UNITED STATES PATENT AND TRADEMARK OFFICE

APPLICATION NO.	FILING DATE	FIRST NAMED INVENTOR	ATTORNEY DOCKET NO.	CONFIRMATION NO.
10/812,557	03/30/2004	Sang-Tae Kim	04-09	3682

Office Action Summary

DETAILED ACTION

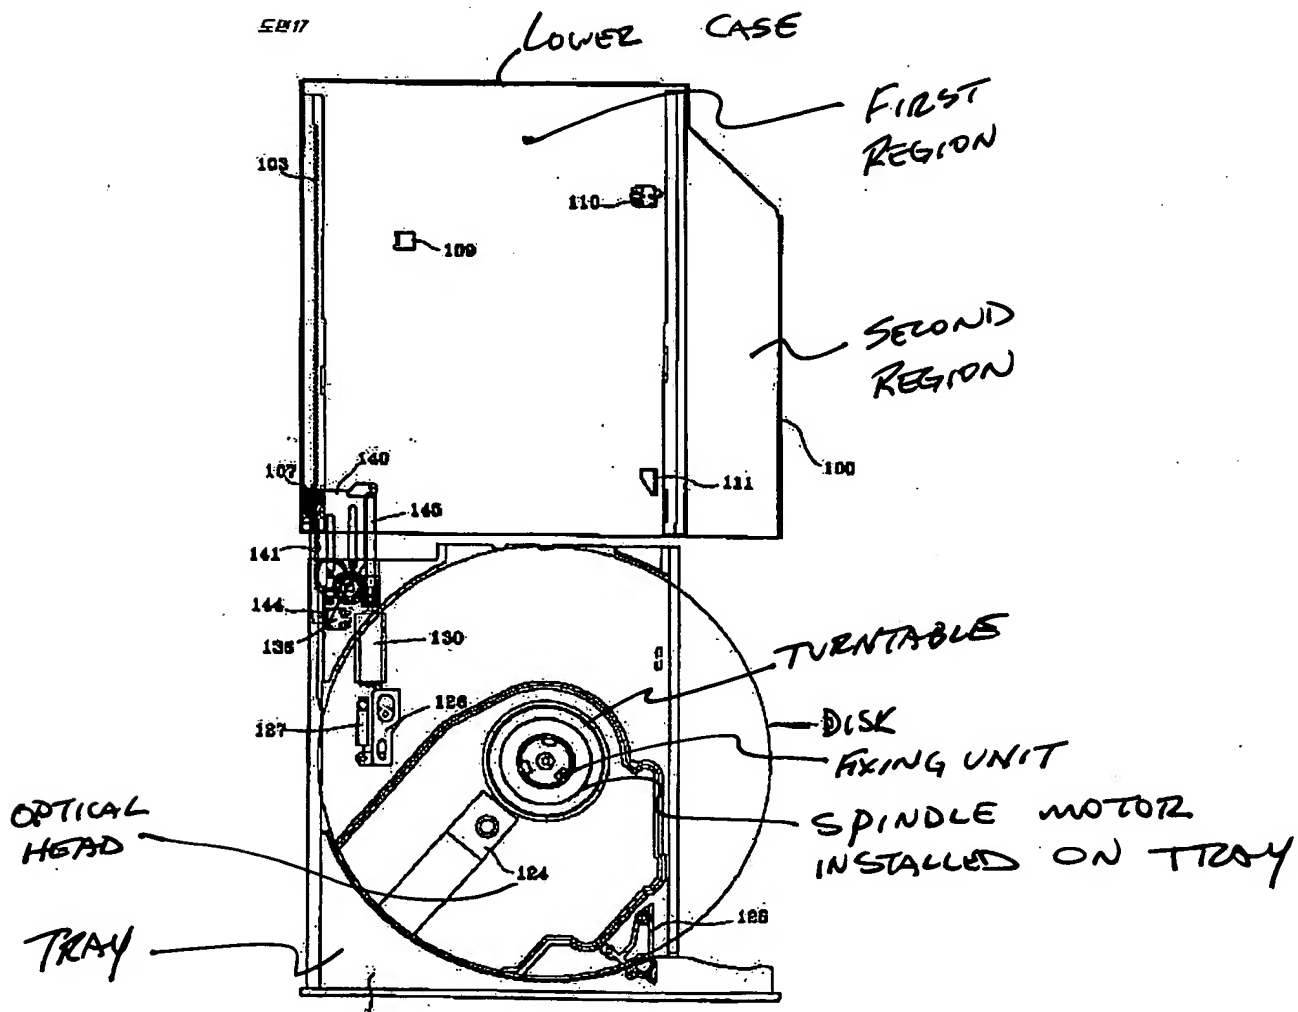
- Regarding claims 1 and 10, Lee teaches a disc drive comprising:
 - a tray 120 for holding a disc D;
 - a lower case [not numbered but shown on page 20-17] on which the tray 120 is installed to be slid;
 - a loading motor 130 for providing a driving force that slides the tray; and
 - a spindle motor [not numbered; inherent property of disc drive] having a turntable 122 and being installed on the tray 120,wherein the disc is secured to the turntable for being rotated by the spindle motor that is installed on the tray [Figure 4 on page 20-9].

"However, Lee which does not even illustrate a spindle motor would not disclose, teach or suggest a spindle motor installed on the tray."

590 F.2d 911, 200 USPQ 500 (CCPA 1979). See MPEP § 2121.04 for more information on prior art drawings as 'enabled disclosures.'” In the instant case, the Examiner maintains that Lee shows a spindle motor that is installed on the tray as claimed in the present invention [see annotated figure above].
